**PLANNING COMMISSION AGENDA**

Tuesday, October 06, 2015  
Breckenridge Council Chambers  
150 Ski Hill Road

## Planning Commission Staff Report

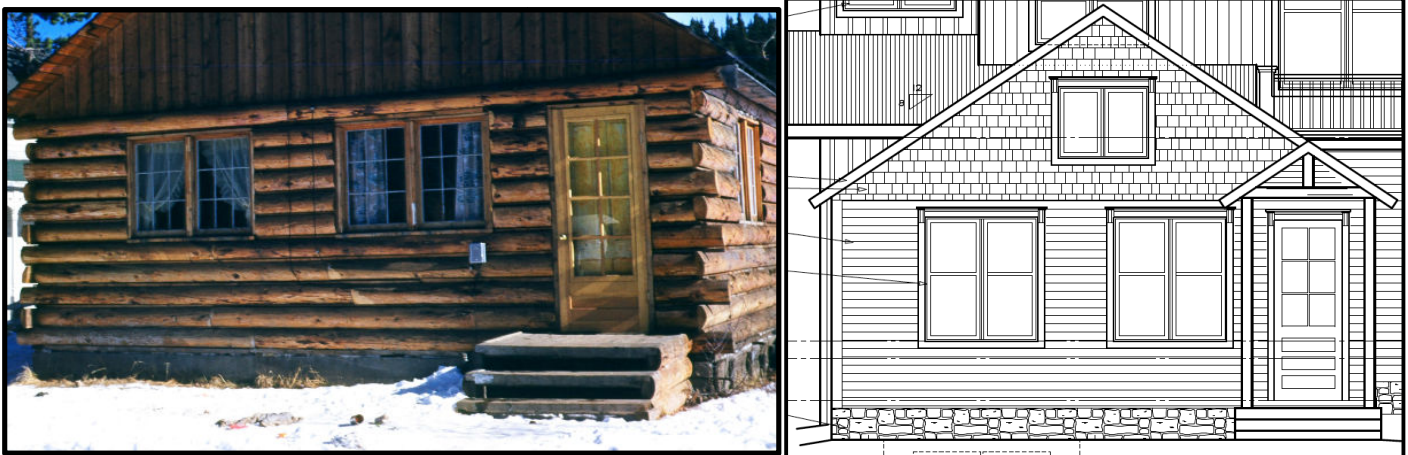
As the Commission may recall, the above house (Sutterley residence), that is on this same block, was found to have historic log beneath the lap siding. This was reviewed by the Commission and the decision was made to remove the lap siding and expose the historic logs. We believe that with two historic log structures along this block, stained log finishes may be appropriate. Does the Commission concur?

A massing model submitted during initial staff review (this does not reflect the exact details of the current submittal) shows the general relationship of the building forms:

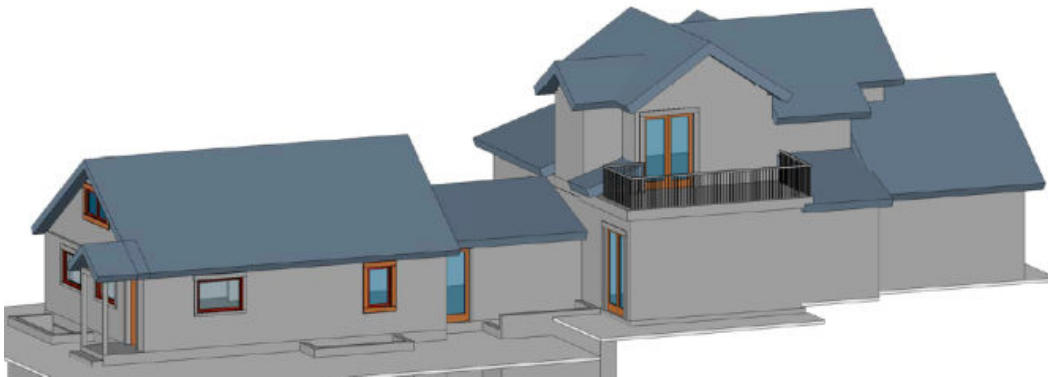
Does the Commission believe the massing is far enough away from the primary façade to allow the 23-foot (2-story) height?

WEST ELEVATION

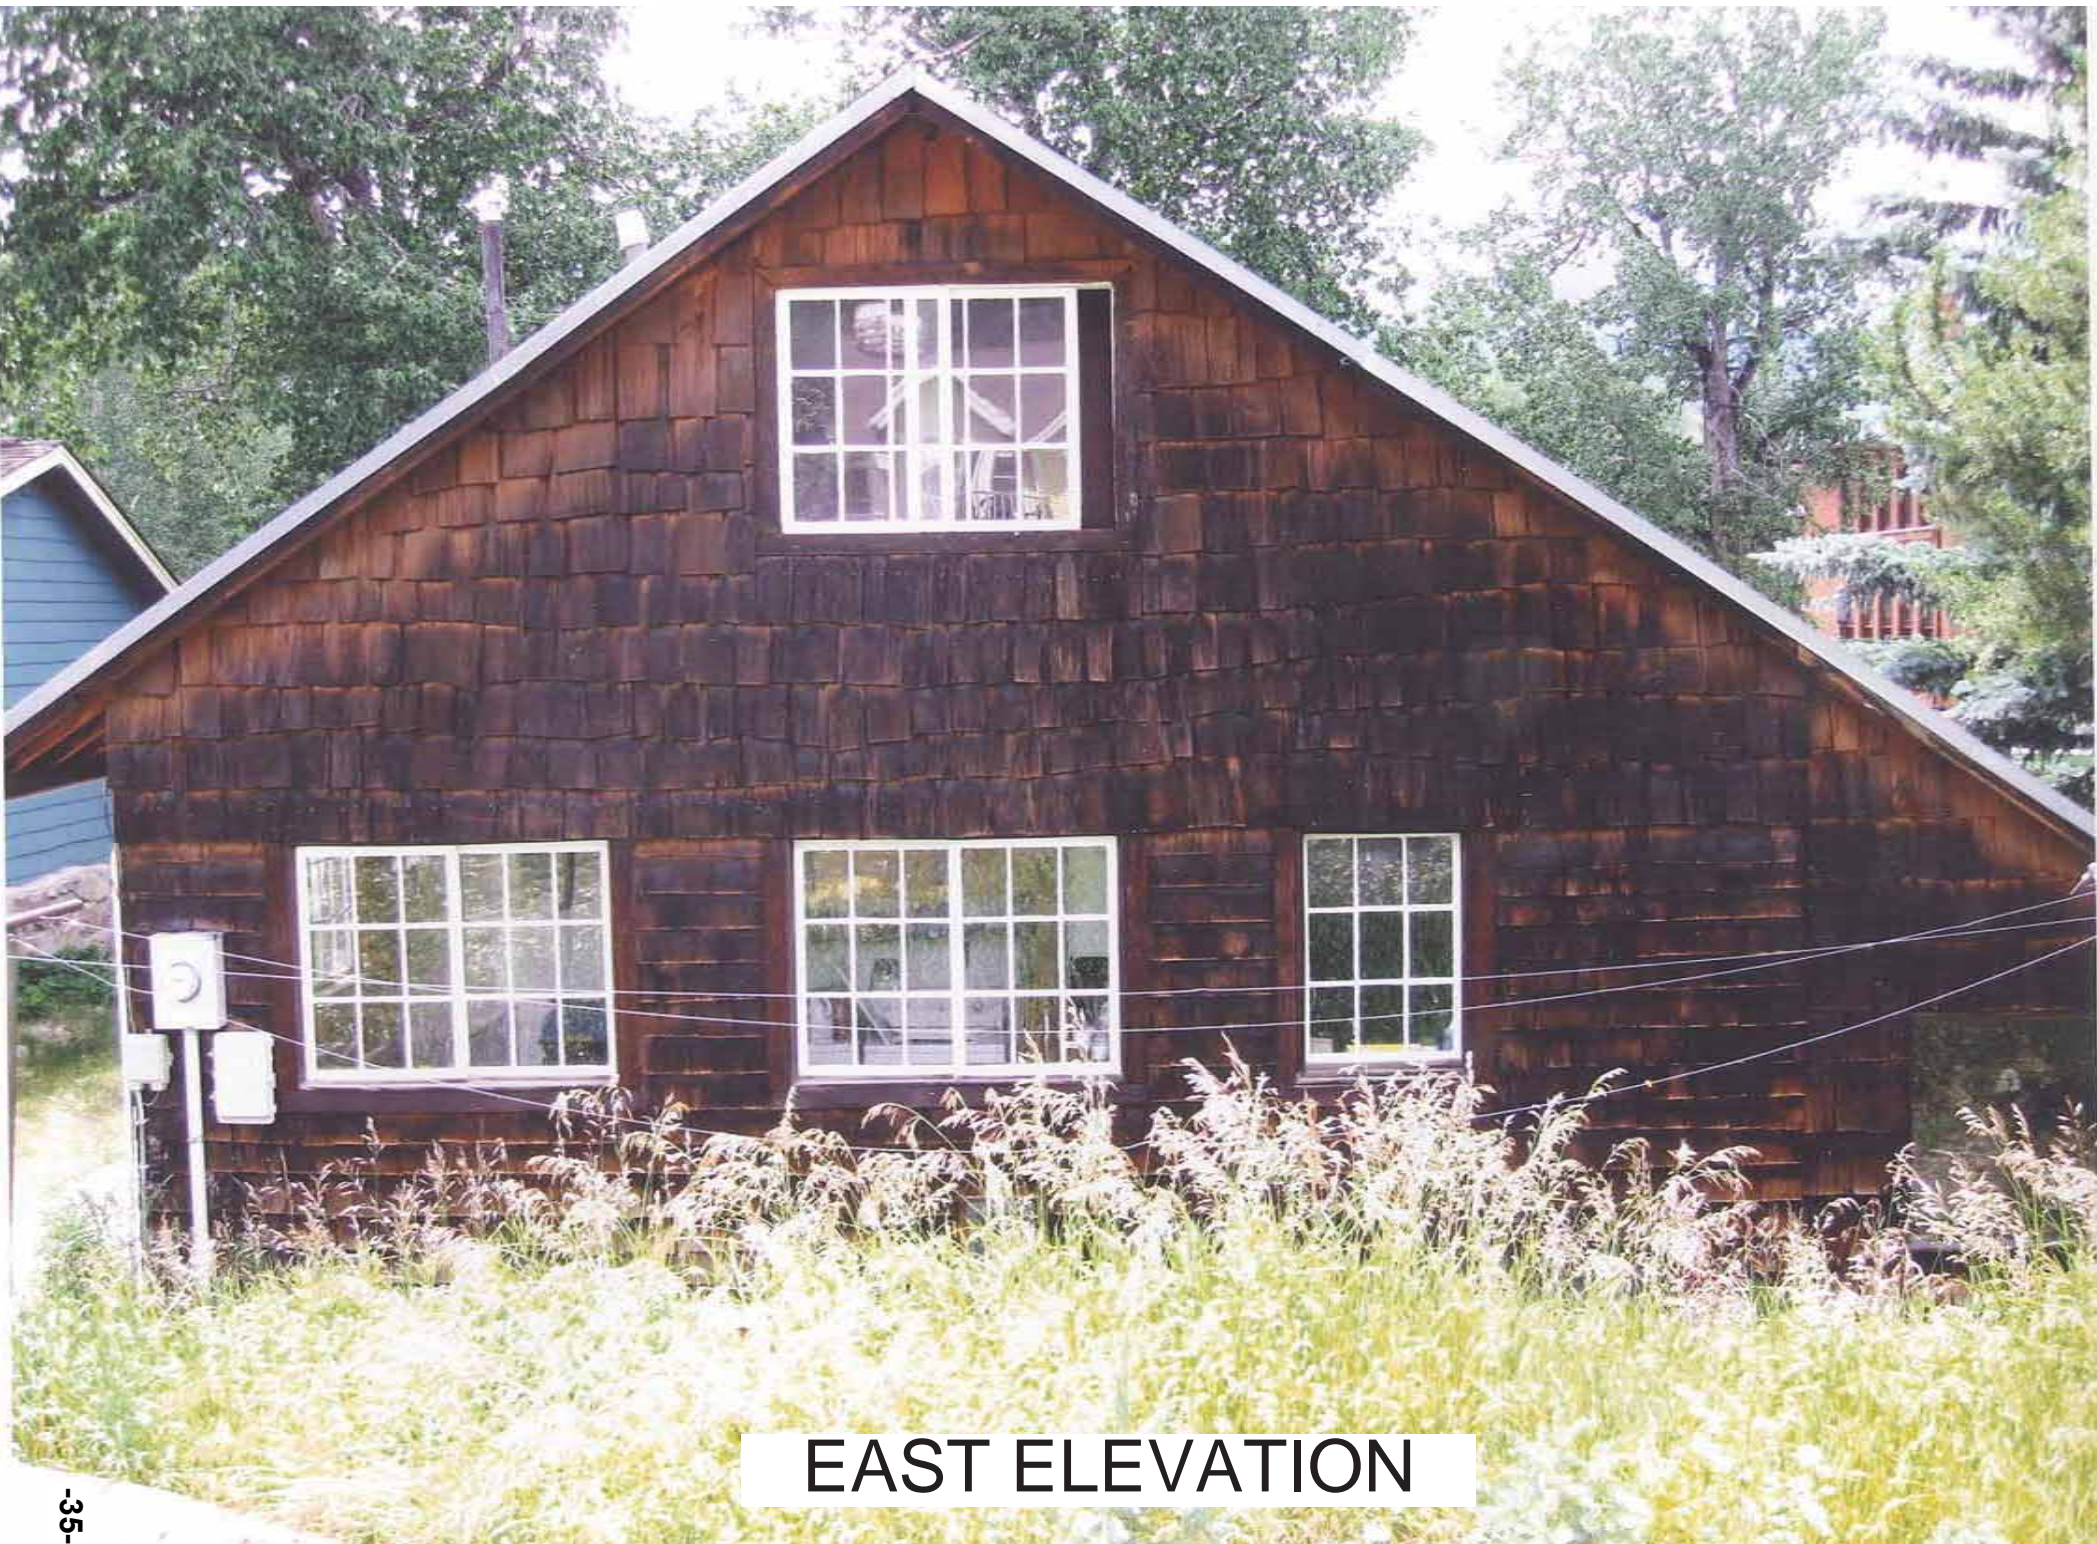
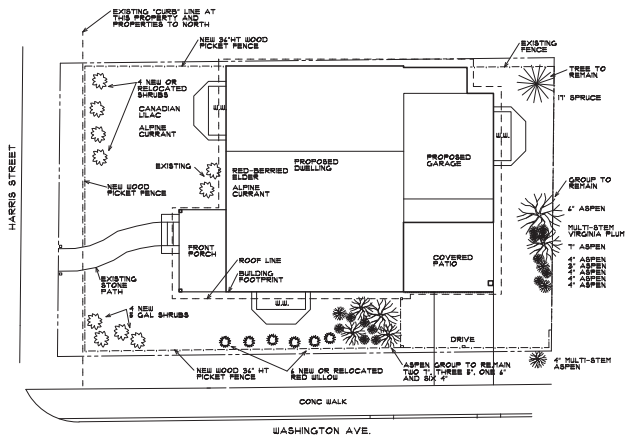
Overall, staff is pleased to see the amount of restoration of historic structures along this block. Although this property does not fall within the Town's Period of Significance, it still represents part of the town's heritage for the "Interim Period" of the town's growth (1943-1960).

The rough point analysis does not currently show a passing score but staff anticipates changes to the drawings that would allow this project to pass a point analysis. We have these specific questions for the commission:

4. Since the applicant is seeking to landmark the historic home, should the plans follow Priority Policy 77, "Maintain original window proportions"?
5. Staff is suggesting solid wood windows instead of wood clad windows for the historic structure. Does the Commission concur?
